Penola Catholic College, Broadmeadows Design Review

onemilegrid has been engaged to provide traffic engineering advice in relation to the proposed new Year 11 and 12 building at Penola Catholic College, Broadmeadows.

Figure 1 Proposed Development Layout

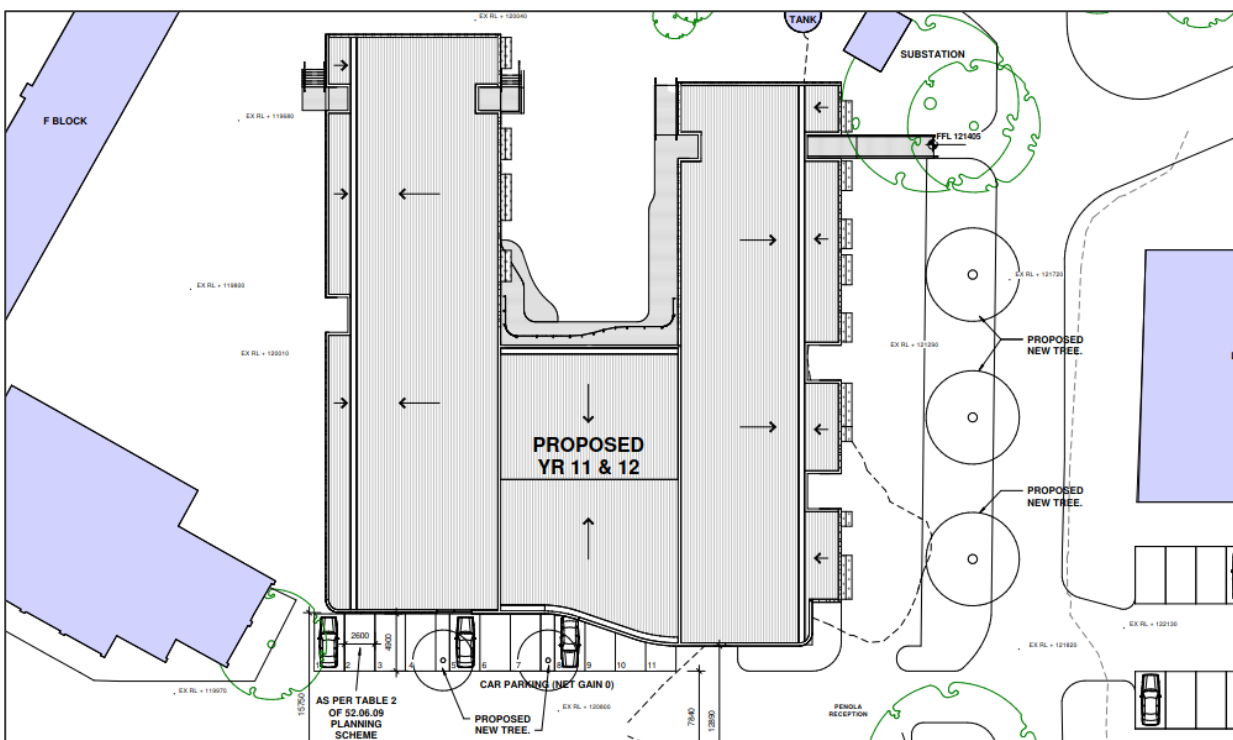
The development does not specifically propose the creation of any new accessways on the site, but rather a slight modification of the existing parking spaces at the frontage of the proposed development. The accessway abutting the modified spaces is proposed to be no more than less than 7.3 metres wide and is considered appropriate.

The modified parking spaces on-site are proposed with a width of 2.6 metres and a length of 4.9 metres, which accords with the requirements of Design Standard 2. The minimum 7.3 metre wide access aisle exceeds the minimum 6.4 metre requirement specified under Design Standard 2.
